PIPER VILLAGE WEST

Early Design Guidance #2
Analytic Design Proposal Packet

Submittal Date
Sep. 23, 2009

Truck Access

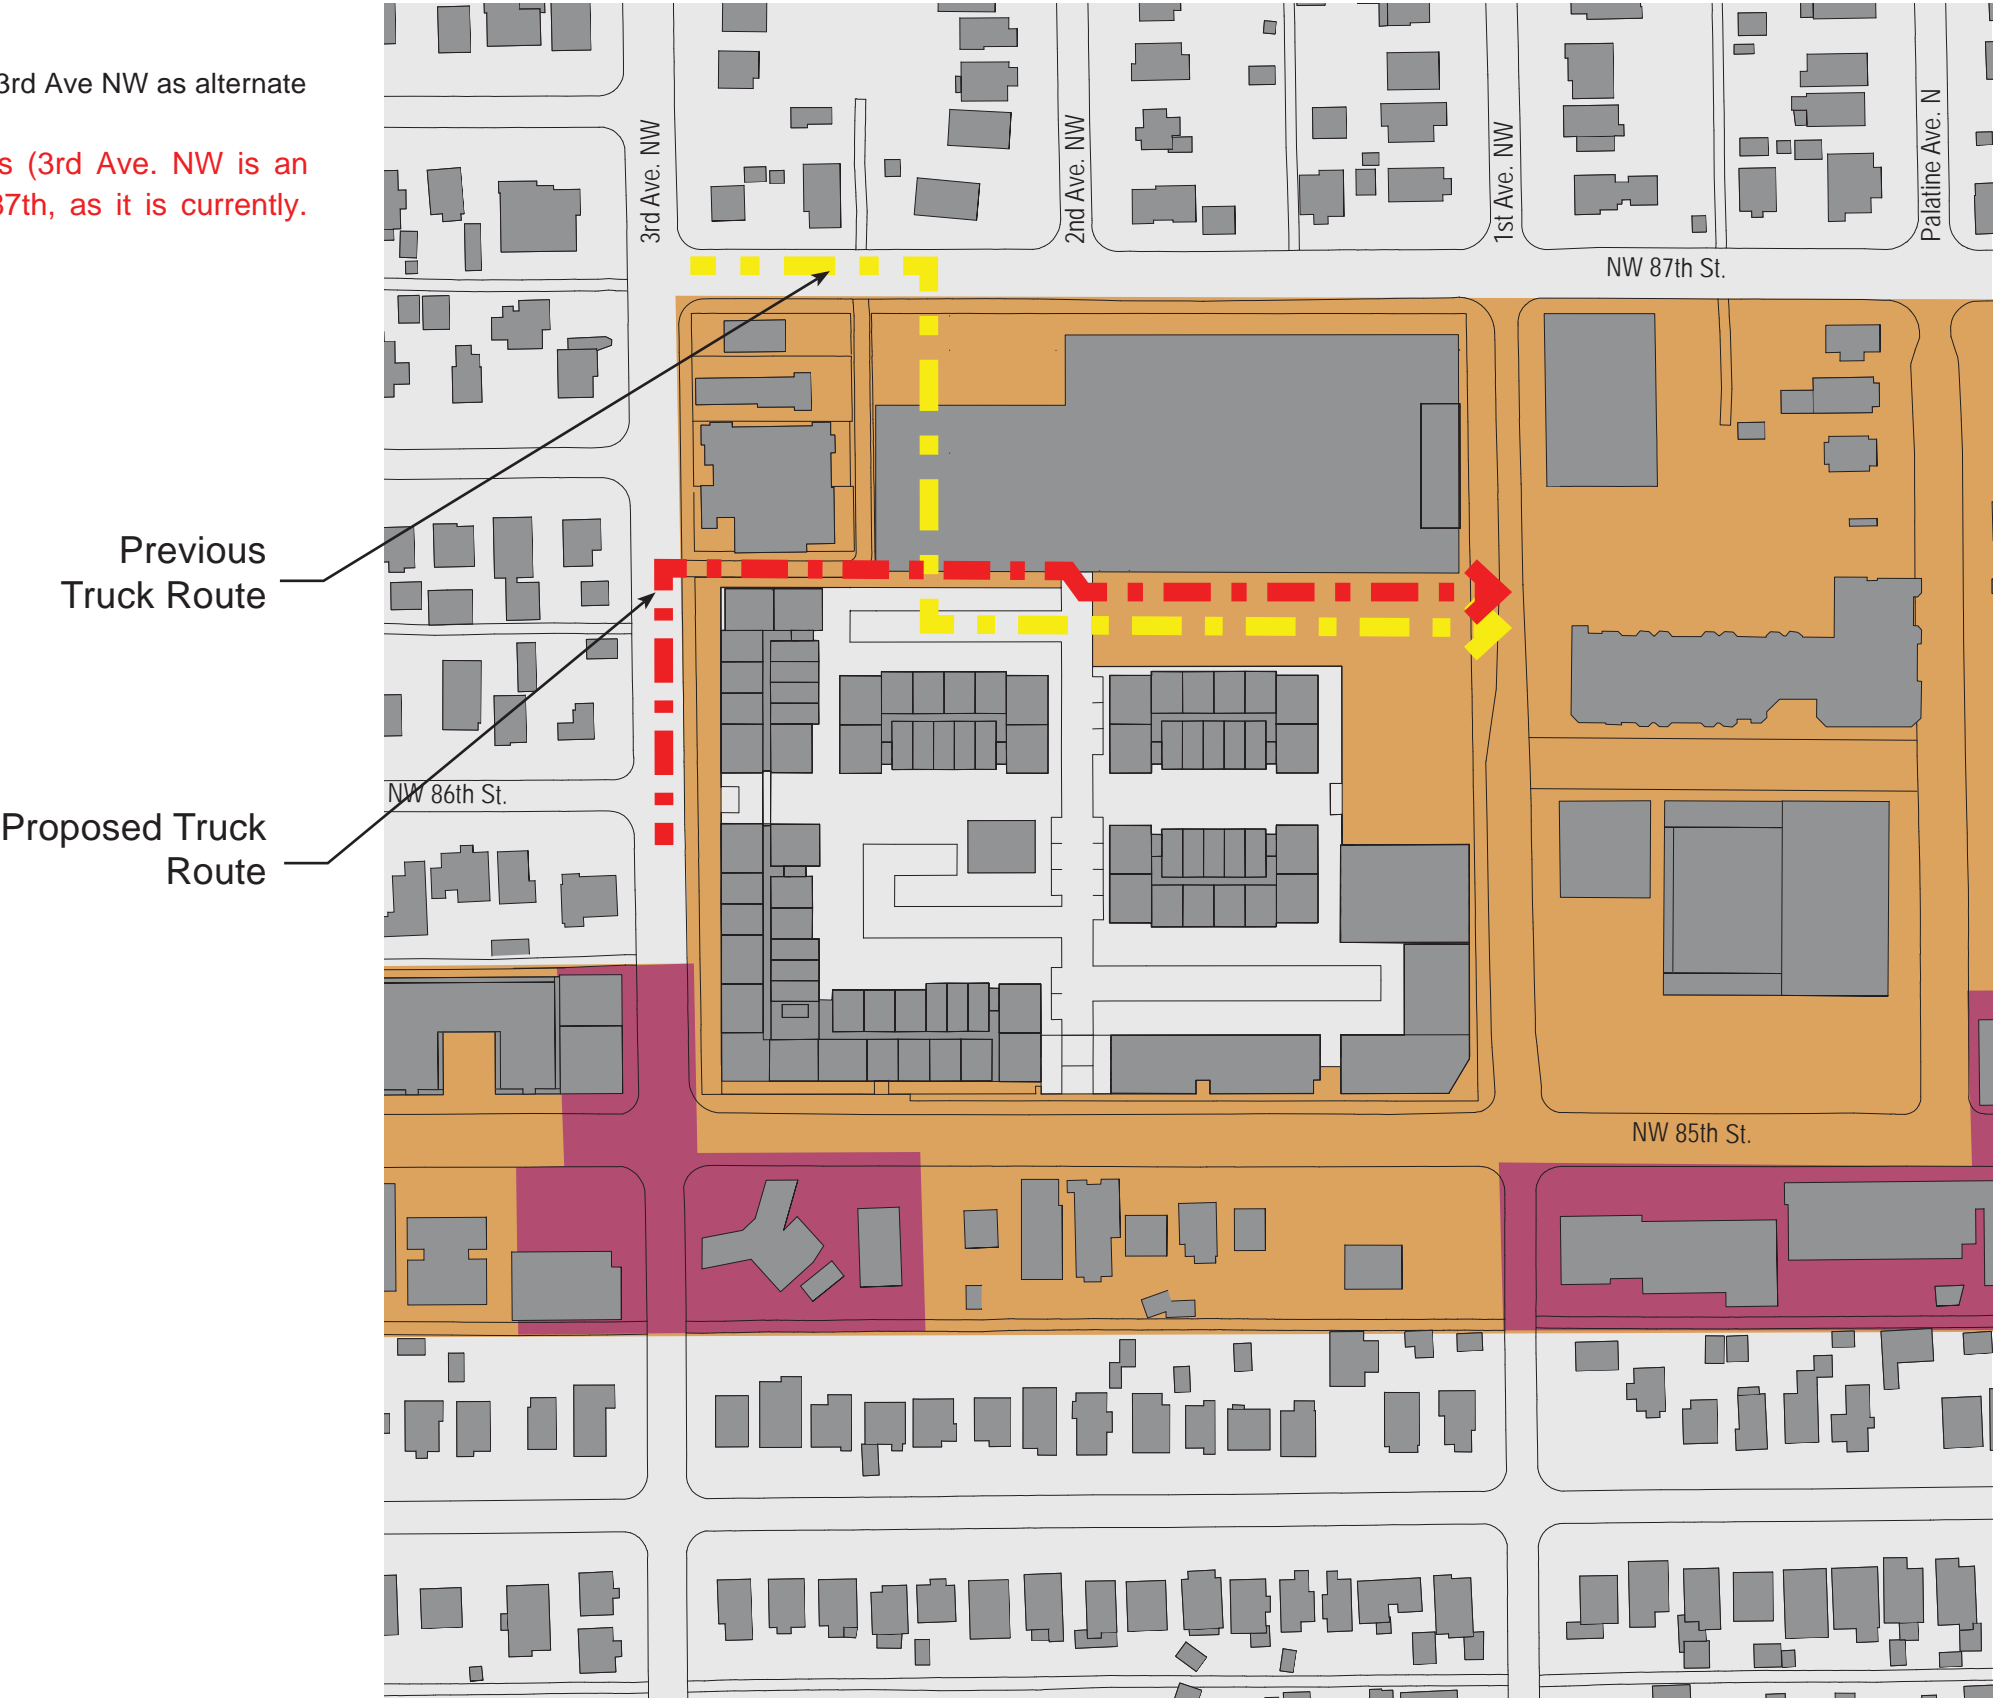
The corner of N.W. 85th and 1st Ave. N.W. in particular would be a good place for a corner entry to a commercial space. Blank walls along the Fred Meyer store and the parking garage should be avoided.

Prefer that it not be on 87th, which is a residential street. Look at 3rd Ave NW as alternate

- 1 A retail entry will be provided at 1st Ave NW and NW 85th, as well as many other locations along the NW 85th St. frontage.
- 2 We propose continuous retail frontage along NW 85th, with strategic breaks in the frontage where site access occurs.
- 3 Through site access points

SDOT prefers that truck access be from non-arterial streets (3rd Ave. NW is an arterial). We propose maintaining truck access from NW 87th, as it is currently. Truck then exit to 1st Ave. NW
